Subject: 2016 CX-9 - CENTER CONSOLE LID RATTLES WHEN DRIVING ON ROUGH ROADS	Bulletin No: 09-052/16
	Last Issued: 10/06/2016

2016 CX-9 vehicles with VINs lower than JM3TC*****114518 (produced before July 18, 2016)

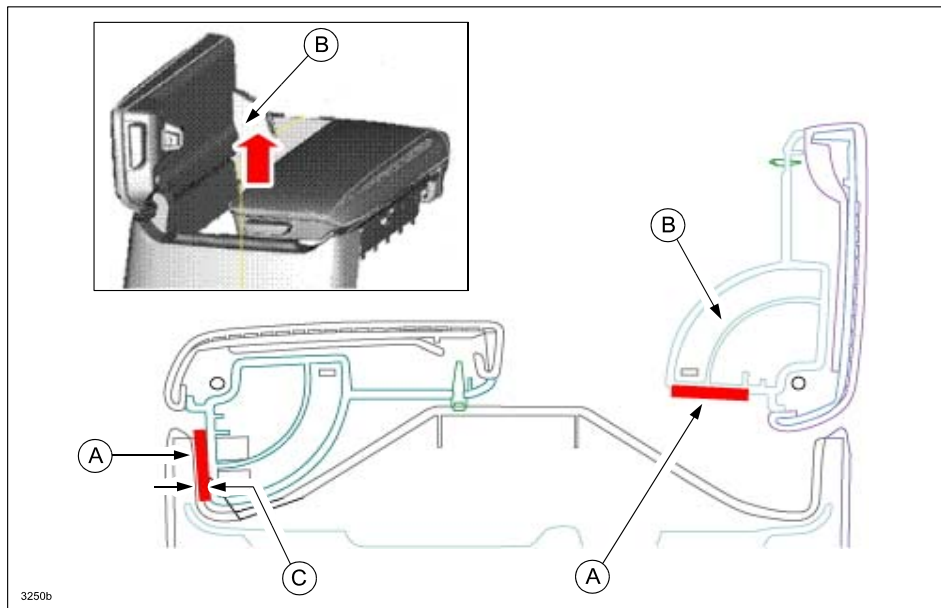
Some vehicles may exhibit a rattling noise from the center console lid while driving on rough roads or when an occupant leans onto the arm rest. Due to variations in the assembly and parts dimensions, some center console lids have play beyond the specifications, which causes a rattling noise. Urethane pads have been attached to the hinge arm of the center console lids to eliminate the noise.

1. Verify the customer concern.
2. Open both center console lids.
3. Degrease the hinge arms (B) where the urethane pads (A) will be attached.
4. Peel off the backing film from the urethane pads (20 x 8 x 4 mm), then attach them to each hinge arm as shown below.

NOTE: The normal clearance when the lid is closed is 2 mm. Attaching the urethane pad decreases the clearance (C) and restricts rattling.

Part Number	Description	Qty.	Notes
TKY0-55-179	Urethane Pad	2	Size: 20 x 8 x 4 mm
